PLANNING, ZONING, & BUILDING DEPARTMENT
PZ&B Staff Combination Memorandum: Architectural Commission and Town Council

SUBJECT: ARC-24-040 (ZON-24-046) 227 ANGLER AVE (COMBO)

MEETING: MARCH 27, 2024 ARCOM
APRIL 10, 2024 TOWN COUNCIL

The applicant has submitted plans, entitled "Demolition of Existing Pergola, Replacement with Loggia, 224 Angler Ave" as prepared Kirchhoff & Associates Architects, dated February 12, 2024.

PROPOSED LOGGIA

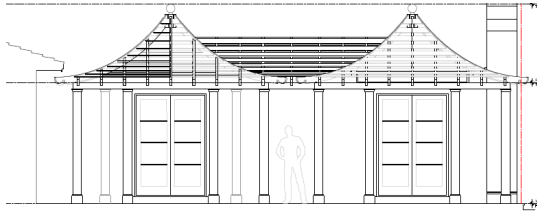
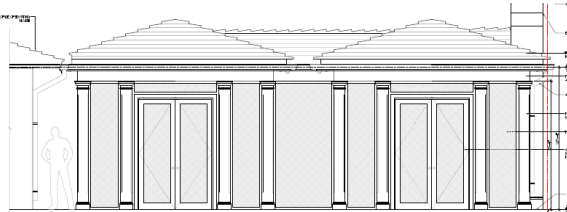
The application is for the construction of an enclosed loggia at the rear of an existing two-story residence. A preliminary review of the project indicates that the application, as proposed, is **inconsistent** with the Town zoning code and requires two variances (1) variance to exceed the allowable lot coverage and (2) variance to exceed the allowable cubic content ratio.

Staff notes that the progression from original construction will continue the deficiency in lot coverage and trigger relief from cubic content requirements. Lot coverage prior to the 167 SF awning replacement was 29.61% just under the 30% permitted. In 2020, with the addition of the 565 SF pergola over existing hardscape, the main house with the pergola covered 34% of the lot and the new loggia, although 15 SF less (33.26%) will still exceed allowable lot coverage. The zoning code permits a 5% credit to CCR for unenclosed loggias, pergolas, porches, terraces and covered patios and a 3% lot coverage exemption for awnings or trellises.

The applicant has made note within this application of rainwater/drainage issues with the current structure as well as concerns with their adjacent neighbor. Approval of the proposed loggia and variances would renew the parcels existing non-conformities.
